**KNOXVILLE/KNOX COUNTY METROPOLITAN PLANNING COMMISSION  
SUBDIVISION REPORT - CONCEPT/USE ON REVIEW**

▶ **FILE #:** 1-SE-15-C  
1-I-15-UR

▶ **SUBDIVISION:** MOURFIELD ROAD SUBDIVISION  
▶ **APPLICANT/DEVELOPER:** ERIC MOSELEY  
**OWNER(S):** Volunteer Development

CONCEPT OVERALL PLAN

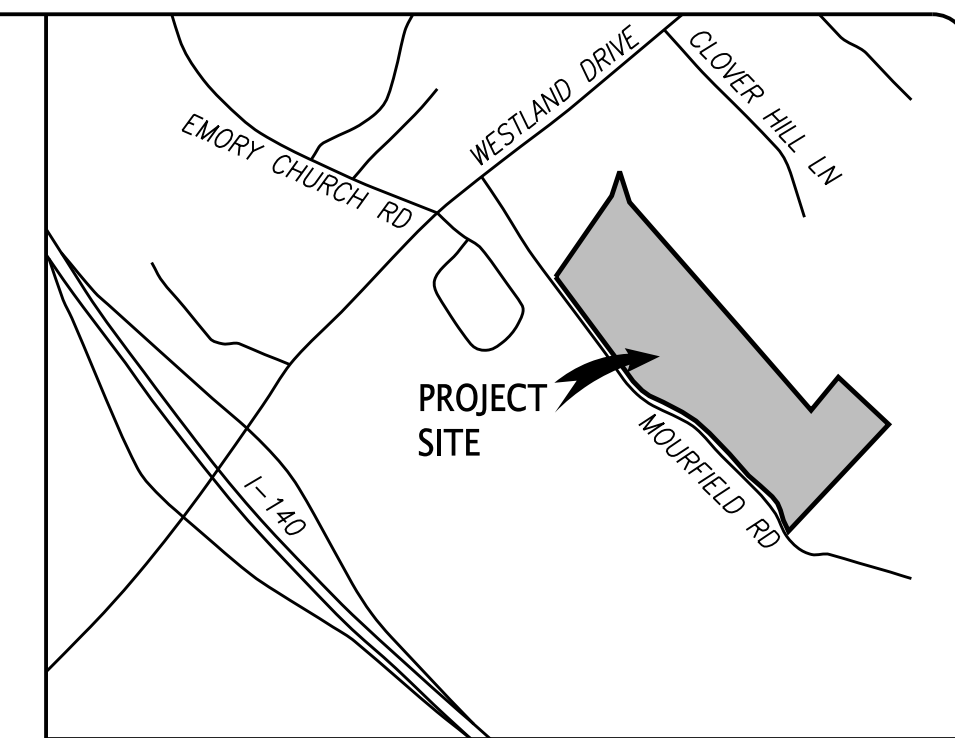
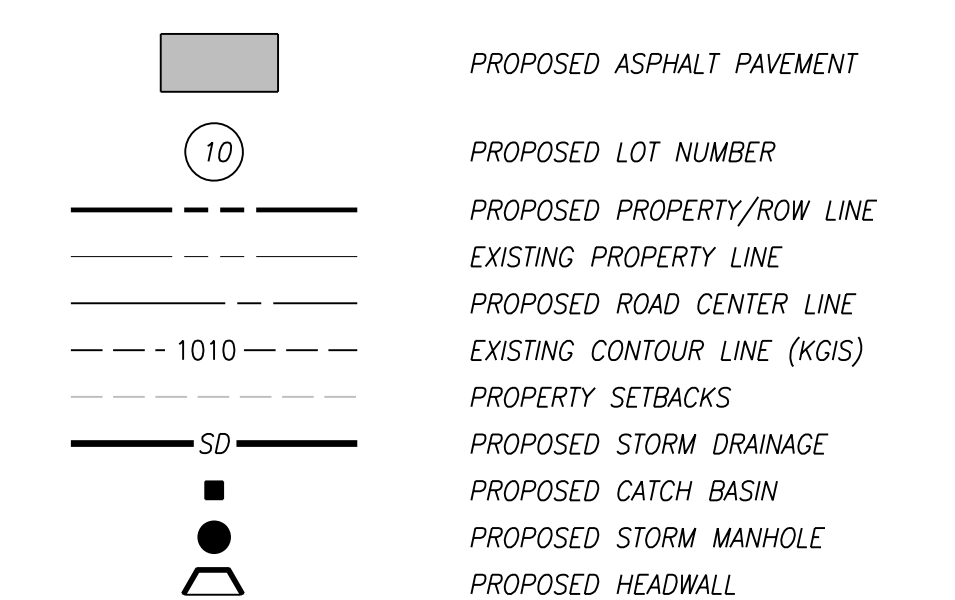
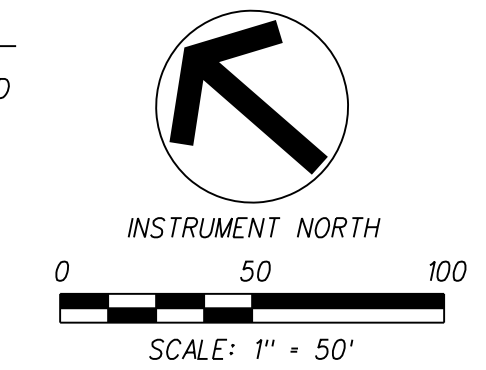
▶ **APPROVE** variances 1 - 5 because the site's topography restricts compliance with the Subdivision Regulations, and the proposed variances will not create a traffic hazard.

**APPROVE** the Concept Plan subject to 13 conditions:

2. Certification on the design plan and final plat by the applicant's surveyor that there is 300 feet of sight distance in both directions on Mourfield Rd. from the proposed subdivision entrance road and from each of the proposed driveways. Approval of all lots is contingent on all these locations being field verified by the Knox County Dept., of Engineering and Public Works for adequate sight distance. Should any of the proposed access locations onto Mourfield Rd. not meet the minimum required sight distance, a new concept plan will be required for the affected lots

3. Prior to obtaining a grading permit provide the Knox County Dept. of Engineering a road profile of Mourfield Rd. that includes the proposed locations of the driveways shown on lots 58-61 and the proposed subdivision entrance road

4. Provision of back-around driveways on all lots with direct access to Mourfield Rd.
5. Place a note on the final plat that all lots with the exception of lots 58-61 will have access from the internal street system only

6. Conducting a stream determination study to determine if the existing creeks/drainage ways are waters of the State and require stream buffers and if they will effect the location of the proposed detention basins

Staff has concerns with this plan with regard to sight distance. The plan calls for the main entrance road and two driveways to access Mourfield Rd. Staff has not been able to verify that either location has the required 300 feet of sight distance. The applicant's engineer believes the sight distance can be provided at the locations in question. Staff has included a number of conditions in this recommendation that specifically address the sight distance question. We have stated that if the sight distance cannot be provided as required, then a new concept plan will be required. The verification of sight distance will be required to be completed before a grading permit is issued for this project.

A second area of concern is the proposed stream buffer along the creek that passes across the northern portion of the site. The buffer is required to be a minimum of 50' wide on each side of the creek bank. Due to the required width of the stream buffer, lot one appears to be unbuildable. The applicant believes the lot is buildable. This is a matter that will have to be resolved at the design plan stage when the detailed grading and drainage plans are reviewed. This may become a non-issue because a detention basin may have to be located in this area.

At the concept plan level the storm drainage plan typically consists of a notation on the plan where the proposed detention basins will be located. After the concept plan is approved the County Engineering Dept. will receive a detailed grading and drainage plan for their review. In this case, the detention basin shown in the northeast corner of the site will most likely need to be relocated because it would be difficult to get all of the lots to drain to this location. Relocating the detention basin may have an impact on the final lot count.

Currently a lot density of 3.5 residences per acre is proposed. Due to the steep slopes and the road layout I believe that 2.0 residences per acre is more practical. I base this off of the fact that the detention basins will be required to be larger than normal due to the larger volume of stormwater runoff due to steeper slopes, runoff increasing due to more roof area, driveways, and roads.

A second reason for the lower density is that the roadway, as laid out, is shown running across the slopes instead of perpendicular to the topographic contours. This is going to cause severe elevation changes on both side of the road to access the residences. This causes concerns with erosion and also is not ideal as residences will be located either 20 to 30 feet above or below the road elevation. This could be alleviated with lower lot densities.

- There are safety issues with multiple driveways having direct access onto Mourfield Rd. For 30 mph speed, a minimum sight distance of 300-feet has to be available before access is approved. Private driveways should not be allowed to access Mourfield from the new development. Especially backing of a car onto the roadway from a private residence.

- It is doubtful that a sight distance of 300-feet is available for the main entrance. This should be proven in the field prior to MPC approval.
- The Knox County regulations (62-60, pg 35) state that the local street maximum grade is 12%. Road "B" on the drawings shows an existing grade of 15%. Road A shows a grade of 12.5%. They should not be approved for greater than 12% unless there is a valid reason for doing so. If the allowable grade has to be raised to 15% to make the subdivision developable, development should not be allowed. Raising from 12% to 15% should be the exception and not the norm. I know that the regulations say that for exceptions it can be raised to 15%. If 15% was the intent, they would not have listed 12% as the maximum grade in the regulations.

- Guidelines were passed in 2012 for the "Hillside & Ridgetop Protection Area Development Standards. These are guidelines for developments in which the slopes are greater than 16%. The guidelines should be honored by the developer as slopes on the northern and southern sides of Road B are very steep. Measures should be enforced to minimize sloughing off of embankments and stormwater erosion velocities upstream and downstream of Road B. There are enough examples of slope failure in the report to understand that Knox County doesn't want to keep approving of developments without doing their due diligence first.

- Lots 35 – 39 are bisected by fairly long and steep slopes that would require very controlled erosion control structures to be put into place prior to construction as they are adjacent to the drainage channel for Mourfield Road. With high stormwater velocities being realized in the drainage channel on Mourfield Rd, any sediment that enters the drainage channel will be transported into the creek immediately. As a side note, these are not very good building sites for the houses that would eventually inhabit the lots.

- The concept drawing and the preliminary construction drawing are not realistic in that they depict a detention pond being located at the northern corner of the site within two streams that are converging. One has been classified as a wet weather stream. The Detention Pond cannot be located at that particular location as the stormwater regulations DO NOT allow the Detention Pond to be located within an existing stream, much less two streams. Waters flowing from the site have to be collected before they are discharged to waters off-site. Off-site streams cannot be directed through new stormwater detention structures, therefore the current locations of the detention basins are not realistic or optimal.

- Stormwater regulation require ALL stormwater from the development to be collected separately from off-site water before being discharged off-site. This is not the case in these plans as water is NOT shown as being collected at the southern part of the site before being discharged off-site. For some reason, detention ponds are located upstream of the lowest point on the site. The subdivision entrance is located close to where a detention pond would probably be required, therefore the subdivision entrance location is not realistic which also affects the sight distance that can be achieved.

- Water from the proposed subdivision would also have to be kept separate before it can be discharged off-site with the existing channel stormwater along Mourfield Rd. The existing channel overflows now when major storms occur. Lots 35, 36, and 58 through 61 are not realistic as residential sites.

- Lot #'s 1, 2, 6, 7, and 8 show the 50-foot buffer. They are not practical for building on if the buffer is honored. The plan is not realistic in this area.

- The size of the detention basins as shown are not realistic for the current stormwater regulations which require it to be sized for a 2-yr to a 100-year storm event. Property along Mourfield road is a very steep and has very fast times of concentration, therefore receive high volumes of water very fast. The size of detention basins that are shown are conceptual, but still not realistic.
